ADDENDUM

Forestside Estates
 Attmar & Palleschi Drive
 Brampton, Ontario
 Attn: **Vince Staffieri**

AM 06

Title: Updated drawings

1:150 A301

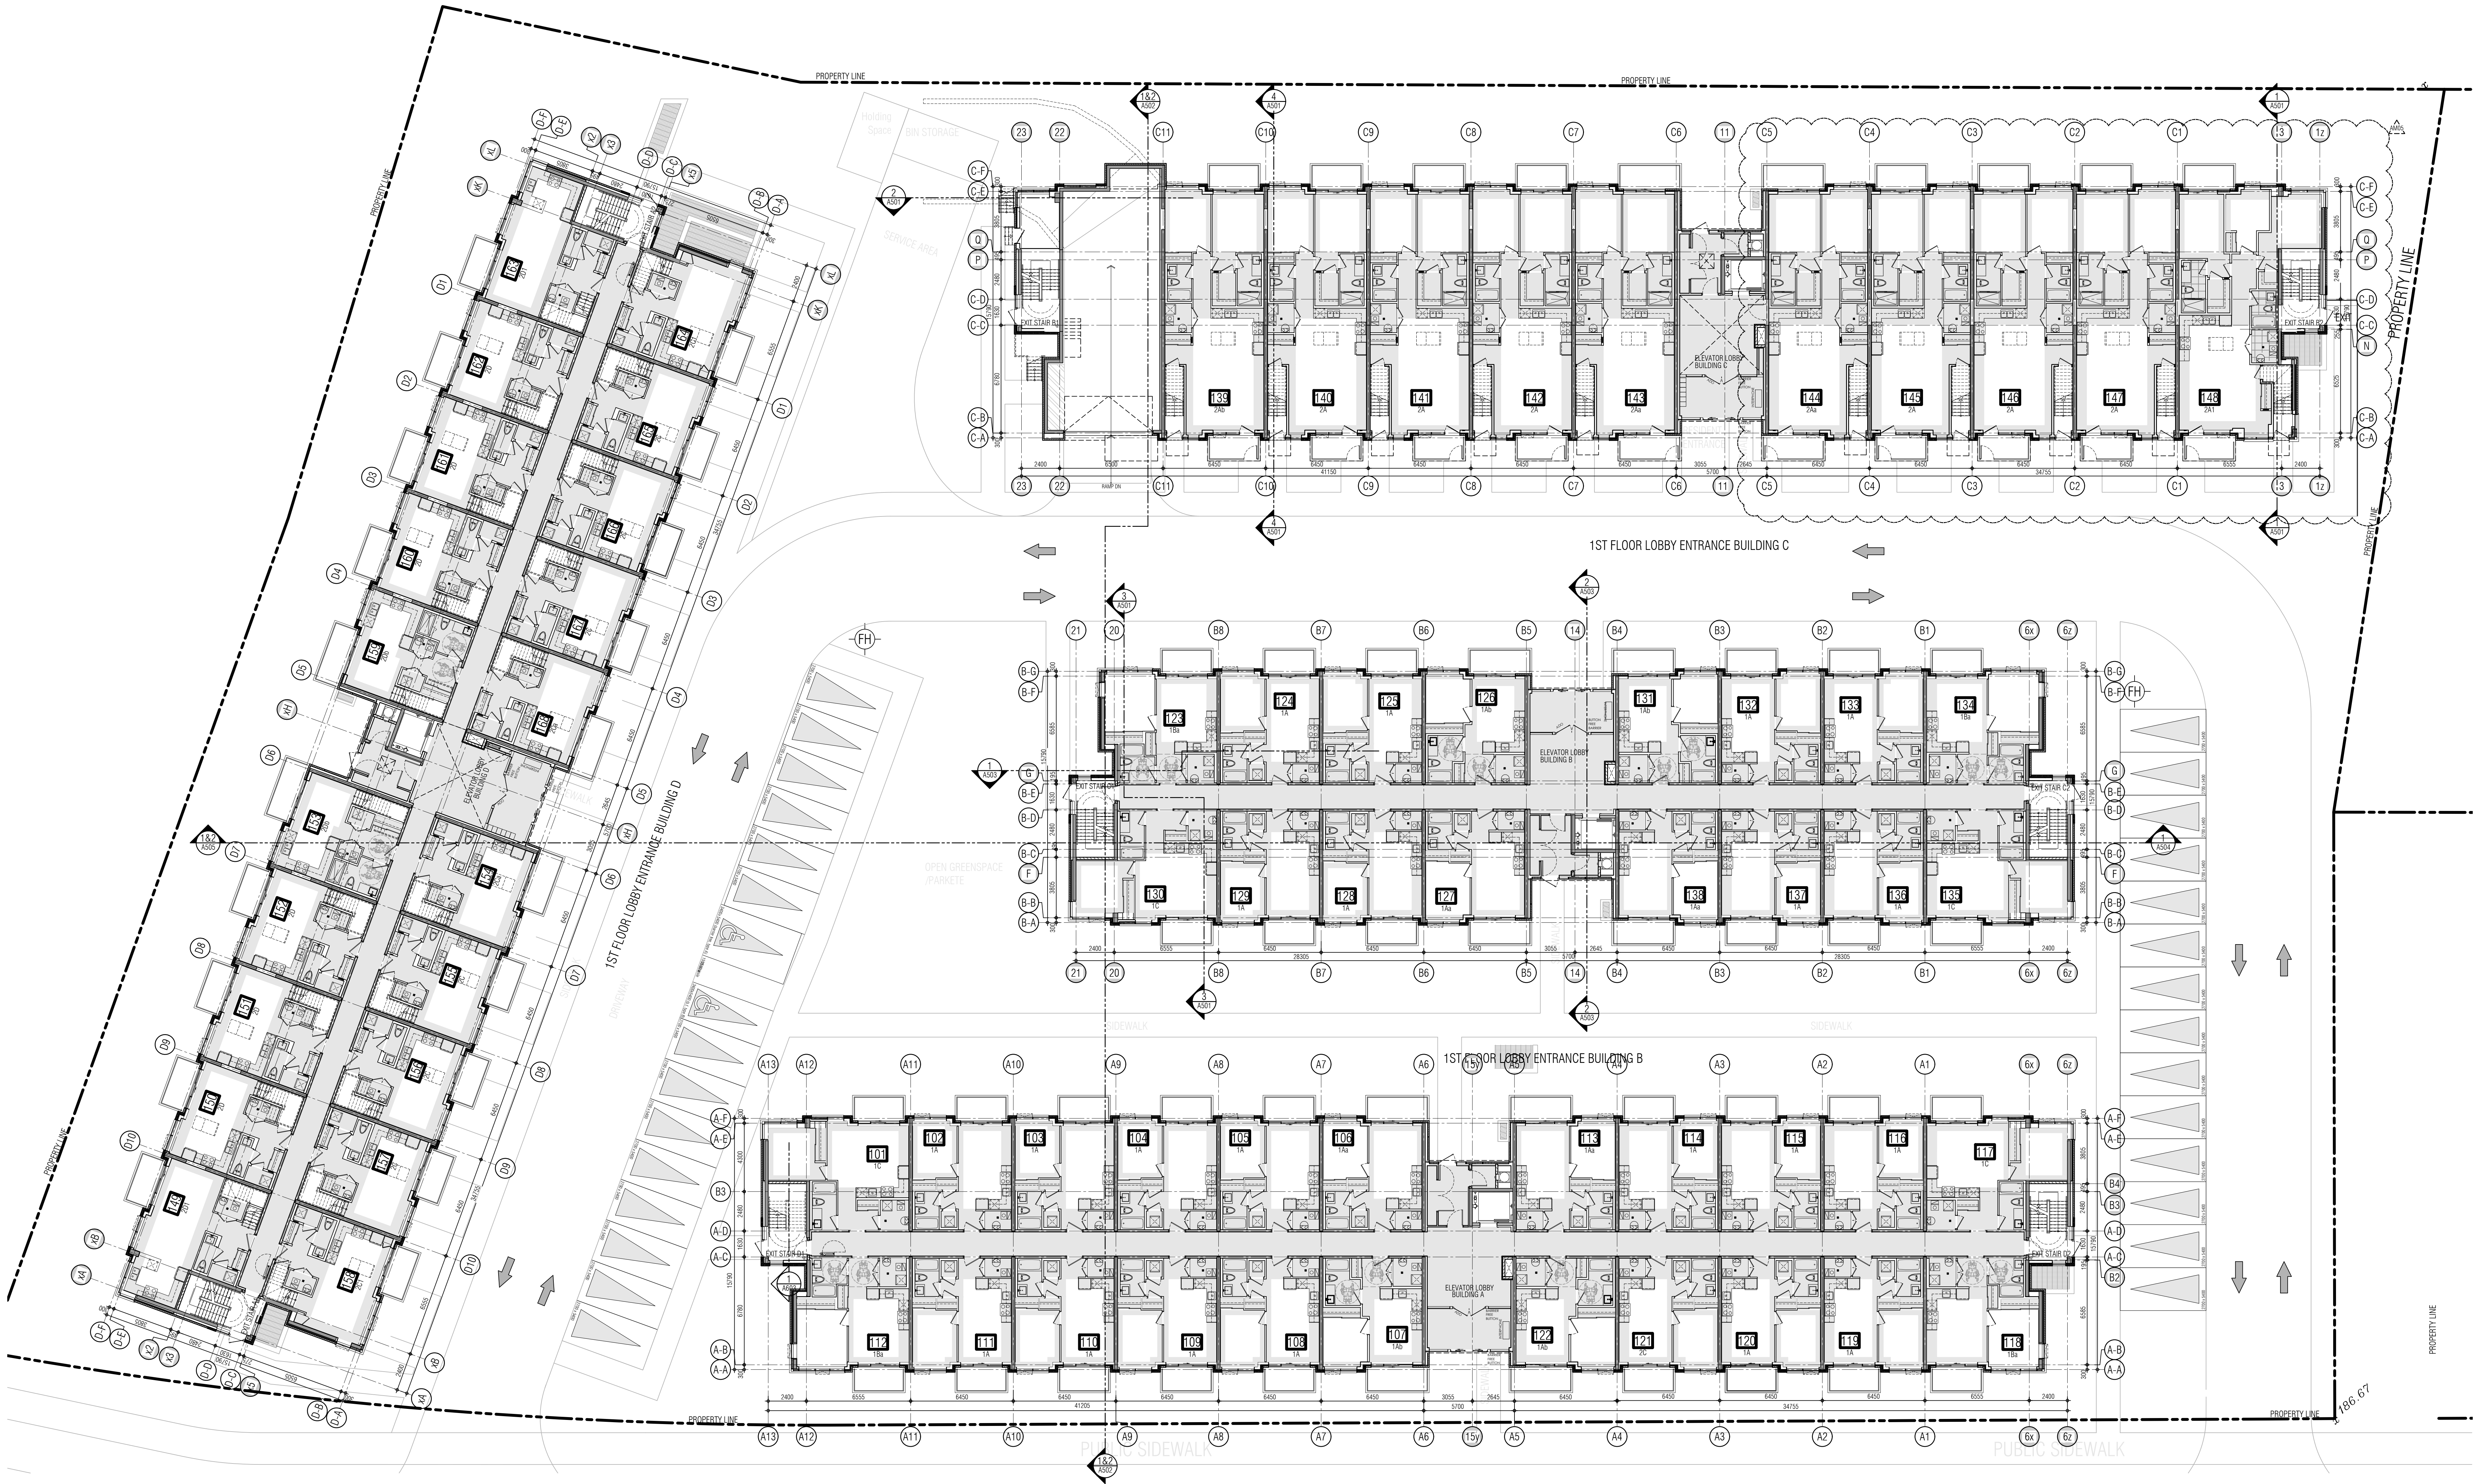
Reference:		Changes:
A301 A302 A303 A304	Floor Plans	Revised Unit Numbering on all Floors to match Marketing Layouts.

Reason: **Revised Unit Numbering as directed by client.**
